Groundwater Application Review Summary Form

Application # G- 18679

PUBLIC INTEREST REVIEW FOR GROUNDWATER APPLICATIONS

A. GENERAL INFORMATION: Applicant's Name: Silver Oak Wine Cellars, LLC County: Yamhill

Figure 2. Well Location Map

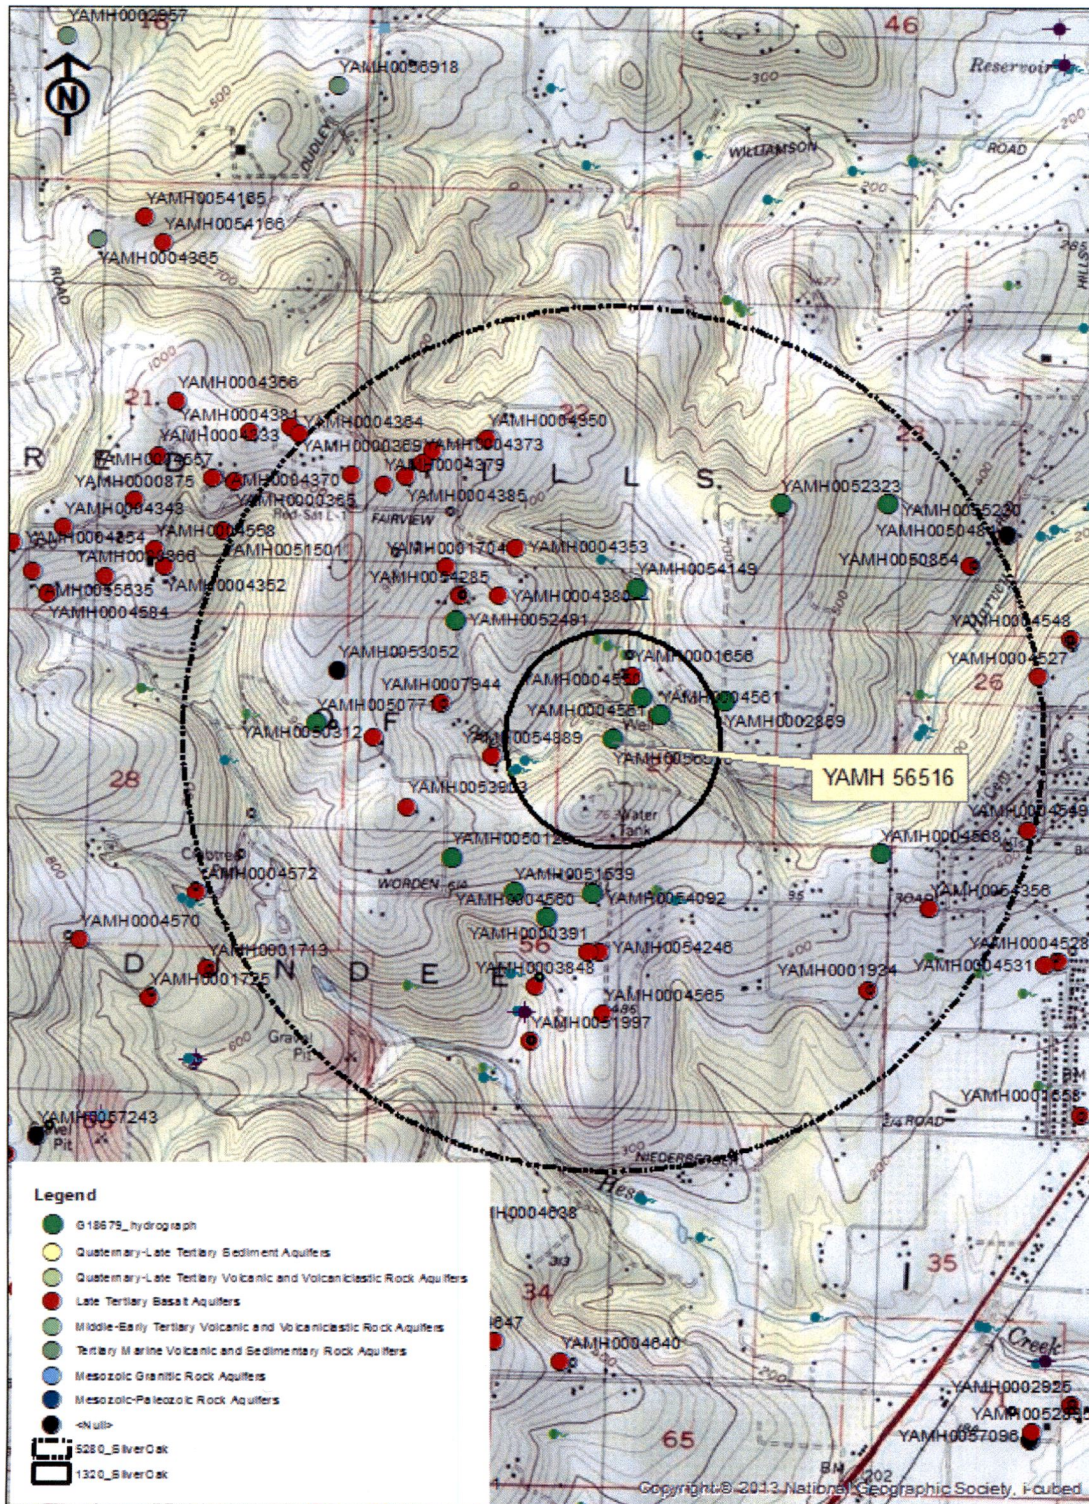
Basis for aquifer hydraulic connection evaluation: The subject well's open interval 9118-301 feet below land surface) is reported in the confined interflow zones of the CRBG. These water-bearing zones are coincident with or above perennial reaches of Harvey Creek within a mile. The creek has incised through several hundred feet of CRBG. Groundwater from the uplands likely discharges to surface water, providing baseflow or spring flow to sustain nearby perennial reaches of the creek.

Comments: *There is no appropriate model to estimate streamflow depletion from pumping in CRBG interflow zones that are incised by streams or discharge to point sources such as springs. Therefore, the percentage of interference at 30 days is not calculated. However PSI is triggered because the well is hydraulically connected and located less than 1/4 mile from Harvey Creek.

C6. **SW / GW Remarks and Conditions:** The applicant's proposed well would be producing from an aquifer that has been found to be hydraulically connected to surface water at a distance of less than 1 mile. The department finds that the proposed use will have the Potential for Substantial Interference per OAR 690-009.

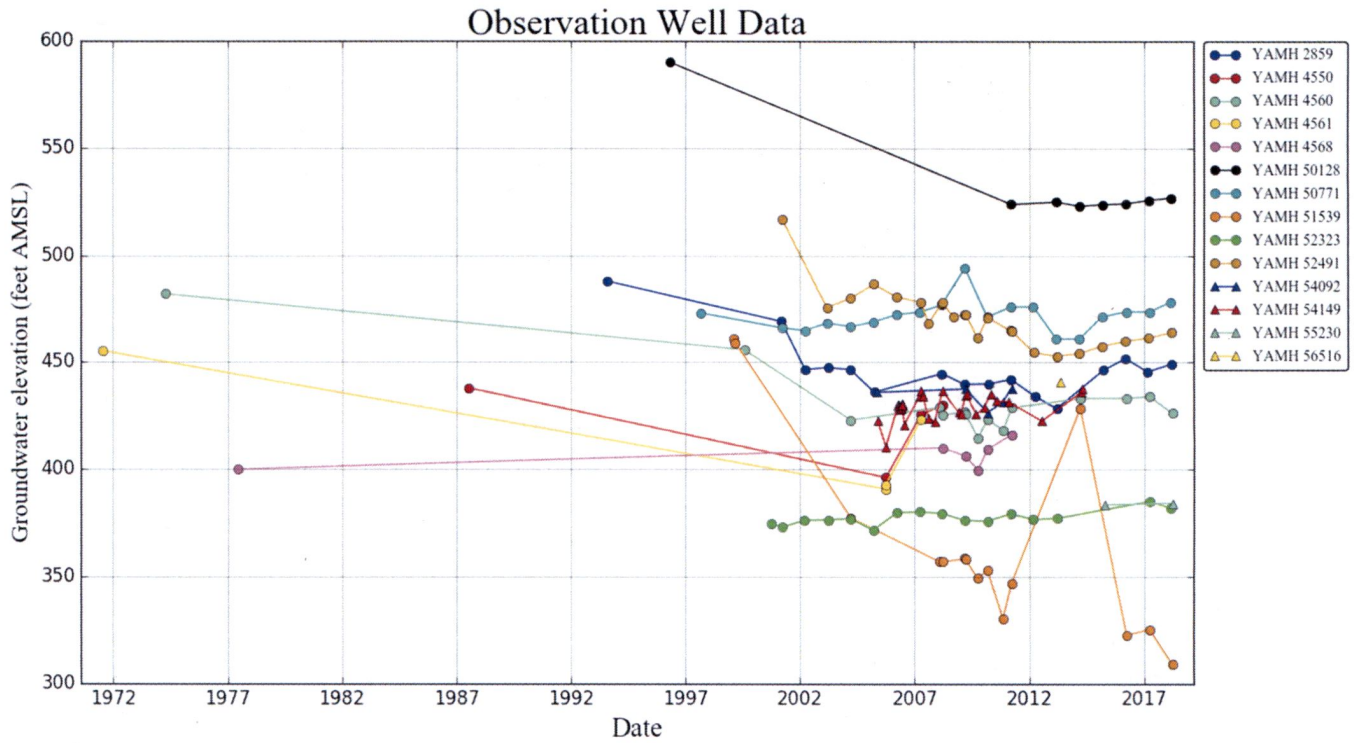
The proposed use of 7.5 acre-feet per year at a maximum rate of 31 gallons per minute (gpm) is unlikely to create drawdown interference with nearby wells that prevents access to water. Nearby wells access a variety of water-bearing zones within the CRBG aquifer system. Well logs in T3S/R3W- Sections 22 and 27 report yields ranging from 1 to 364 gpm, with a median yield of 25 gpm. Wells that access the upper elevation water-bearing zones show reasonably stable trends (see Figure 3), while wells that access the lower elevation water bearing zones show slightly more long-term decline. The subject wells are expected to access upper elevation water-bearing zones, with a water-level elevation of approximately 500 ft above mean sea level. The proposed magnitude of development is not expected to cause injurious well-to-well interference with neighbors or long-term water level decline. Water use and water level monitoring conditions are recommended to protect existing users.
